**FRONT WHEEL TIRE BEAD CLAMP AND
REAR BRAKE SIDEPLATE / SX-175**

A certain number of York produced SX-175 motorcycles, within the range of VIN' s listed below, will require corrective modification as specified in this bulletin under Item 1 and Item 2.

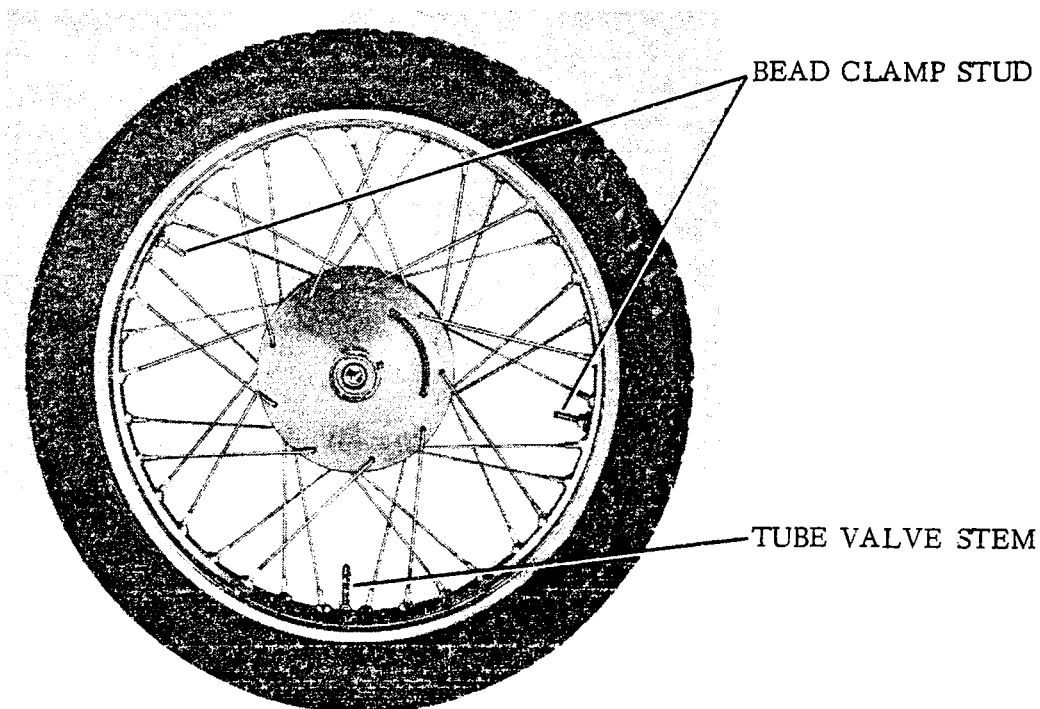
ITEM 1: One of the two front tire bead clamps was not installed on SX-175 motorcycles within the range of VIN's listed. As a result, the rubber rim strip located between the rim and inner tube is exposed through the rim hole which is normally occupied by the missing tire bead clamp. This could possibly, after a period of time, result in some deterioration of the rubber rim strip which could allow the tube to contact the rim hole resulting in abrasion of the tube and possible tube failure.

Remove tire bead from one side of rim only and remove tube and rim strip. Assemble additional tire bead clamp to rim opposite present bead clamp and loosely assemble washers and nut to bead clamps. The following illustration shows the correct location of valve stem hole between tire bead clamps.

To correct this condition, you are required to install an additional tire bead clamp assembly on the front wheel of the affected vehicles. Also, the tube valve stem must be relocated in the rim to achieve more correct balance. Assembling instructions follow.

With hole in rim strip positioned at tube valve stem hole, assemble rim strip to rim, positioning it over bead clamps. With wheel assembly in a vertical position, push down on tire to allow access to align rim strip over spokes. Reinstall tube with valve stem located as shown.
